Contract #: 04-0120F4Cty: SF/ALA Rte: 80 PM: 13.2/13.9File #: 69.25B**QUALITY ASSURANCE -- NON-CONFORMANCE REPORT****Location:** Changxing Island, Shanghai, China**Report No:** NCR-000782**Prime Contractor:** American Bridge/Fluor Enterprises, a JV**Date:** 01-Jul-2010**Submitting Contractor:** Zhenhua Port Machinery Company, Ltd (ZPMC), Changxing Island**NCR #:** ZPMC-0744**Type of problem:**

Bridge No: 34-0006**Component:** SEG11AE, X151C to EP170A at PP96**Reference Description:** Missed UT Indication**Description of Non-Conformance:**

To:	AMERICAN BRIDGE/FLUOR, A JV 375 BURMA ROAD OAKLAND CA 95607	Date:	05-Jul-2010
Dear:	Mr. Charles Kanapicki	Contract No:	04-0120F4 04-SF-80-13.2 / 13.9
Attention:	Mr. Thomas Nilsson Project/Fabrication Manager	Job Name:	SAS Superstructure
Subject:	NCR No. ZPMC-0744	Document No:	05.03.06-000743
Reference Description:	Missed UT Indication

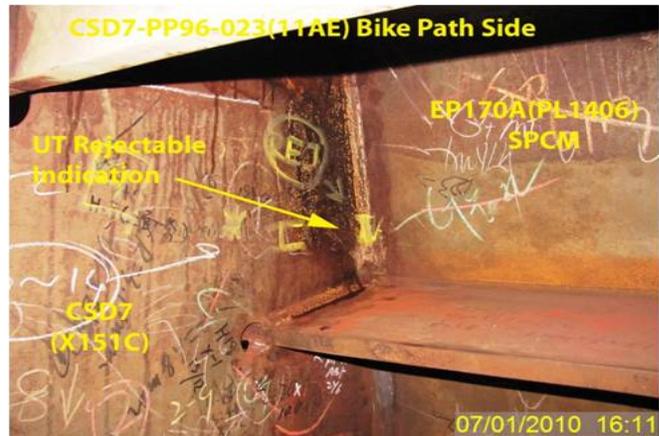
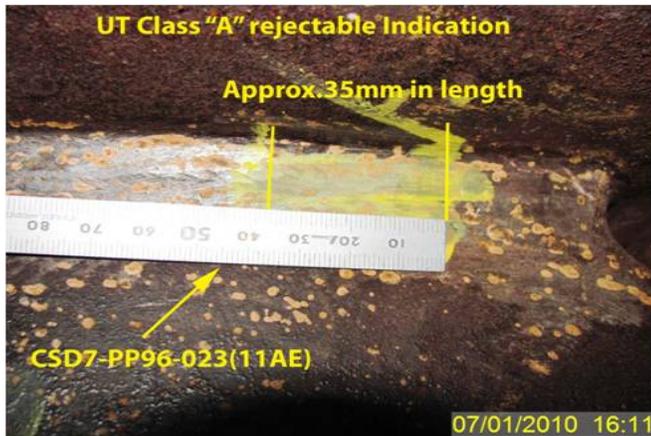
During the Quality Assurance Ultrasonic Testing (UT) review of welds located on Orthotropic Box Girder (OBG) segment 11AE, QA discovered the following issues:

- One (1) longitudinal linear indication measuring approximately 35mm in length.
- The indication dbS rating is a +4.
- The Y distance for this indication is 35 mm from bottom cope hole.
- Material thickness is 20mm.
- The depth of the indication is approximately 12mm.
- The weld is identified as CSD7-PP96-023 at Bike Path side, panel point (PP) 96.
- The weld was a Fillet Weld according to approved shop drawing but due to excessive root gap, ZPMC has changed the joint to a Complete Joint Penetration (CJP) "T" joint.
- This joint connects the Corner Assembly Diaphragm (X151C) to Edge Plate EP170A (PL1406A).
- The weld is designated as Seismic Performance Critical Material (SPCM).
- The indication is clearly marked on or near the weld.
- Segment 11AE is located at outside near trial Assembly Area.

The Notice of Witness Inspection (NWIT) No. is 006079. The indication is located in an area previously tested and accepted by ZPMC Quality Control (QC) personnel. As per the contract documents, ZPMC's QC personnel are required to perform hundred (100%) percent UT inspection of this weld.

AWS D1.5-02 Section 6; Table 6.3 specifies a class “A” indication as having a rating of 10dbs and under for material thicknesses 8mm through 20mm.

Reference Resolution: ZPMC has repaired the missed indication and is providing NDT records to show the weld is acceptable.

ZPMC has repaired the missed indication and is providing NDT records to show the weld is acceptable. ZPMC QA has discussed this missed indication with ZPMC's NDT department head to express the unacceptable trend. Based on this ZPMC requests closure of this NCR.

The proposed resolution is acceptable. This NCR is considered closed.

Component: SEG11AE, X151C to EP170A at PP96

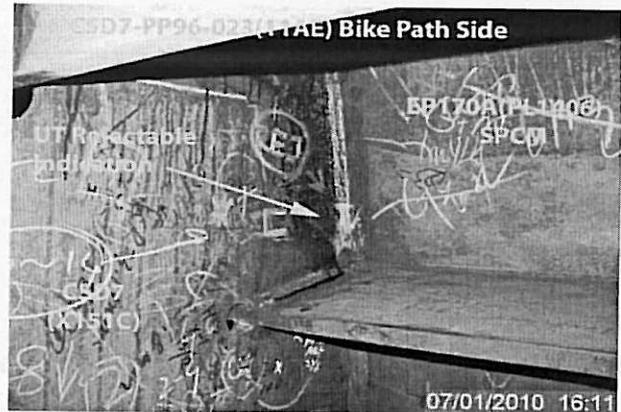
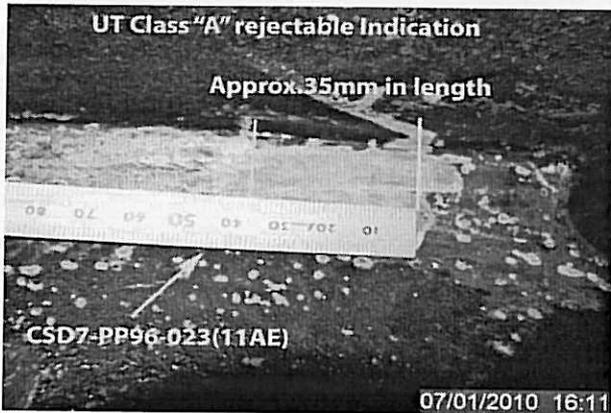
During the Quality Assurance Ultrasonic Testing (UT) review of welds located on Orthotropic Box Girder (OBG) segment 11AE, QA discovered the following issues:

- One (1) longitudinal linear indication measuring approximately 35mm in length.
- The indication dbS rating is a +4.
- The Y distance for this indication is 35 mm from bottom cope hole.
- Material thickness is 20mm.
- The depth of the indication is approximately 12mm.
- The weld is identified as CSD7-PP96-023 at Bike Path side, panel point (PP) 96.
- The weld was a Fillet Weld according to approved shop drawing but due to excessive root gap, ZPMC has changed the joint to a Complete Joint Penetration (CJP) "T" joint.
- This joint connects the Corner Assembly Diaphragm (X151C) to Edge Plate EP170A (PL1406A).
- The weld is designated as Seismic Performance Critical Material (SPCM).
- The indication is clearly marked on or near the weld.
- Segment 11AE is located at outside near trial Assembly Area.

The Notice of Witness Inspection (NWIT) No. is 006079. The indication is located in an area previously tested and accepted by ZPMC Quality Control (QC) personnel. As per the contract documents, ZPMC's QC personnel are required to perform hundred (100%) percent UT inspection of this weld.

AWS D1.5-02 Section 6; Table 6.3 specifies a class "A" indication as having a rating of 10dbs and under for material thicknesses 8mm through 20mm.

Repair said indication and perform NDT required to verify weld quality.

Contractor supplied post repair NDT documentation verifying weld is in conformance with Contract weld quality requirements. Contractor has also taken action directly with NDT Technicians to avoid similar issues in the future.
